ECE/TRANS/WP.29/2006/88
9 August 2006

PROPOSAL FOR 04 SERIES OF AMENDMENTS TO REGULATION No. 48

(Installation of lighting and light-signalling devices)

Submitted by the Working Party on Lighting and Light-Signalling (GRE)

Model A

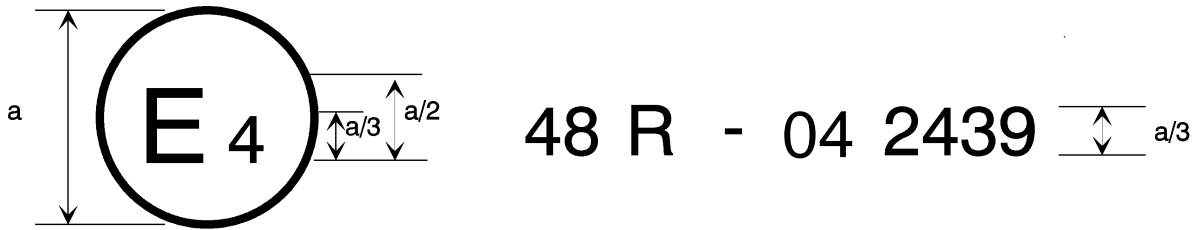
Annex 2, amend to read:

The above approval mark affixed to a vehicle shows that the vehicle type concerned has, with regard to the installation of lighting and light-signalling devices, been approved in the Netherlands (E4) pursuant to Regulation No. 48 as amended by the 04 series of amendments. The approval number indicates that the approval was granted in accordance with the requirements of Regulation No. 48 as amended by the 04 series of amendments.

Model B

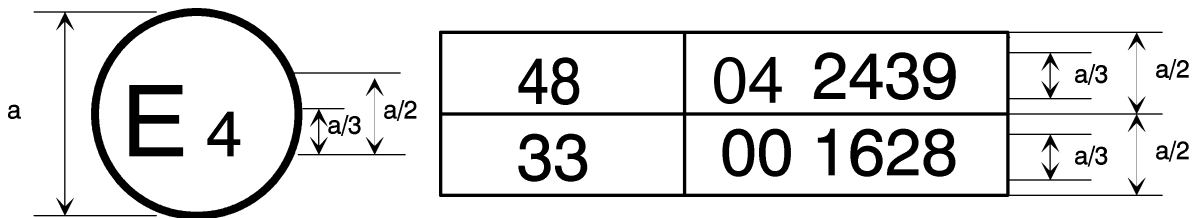
The above approval mark affixed to a vehicle shows that the vehicle type concerned has been approved in the Netherlands (E4) pursuant to Regulation No. 48 as amended by the 04 series of amendments and Regulation No. 33. ^{1/} The approval number indicates that, at the dates when the respective approvals were given, Regulation No. 48 was amended by the 04 series of amendments and Regulation No. 33 was still in its original form.
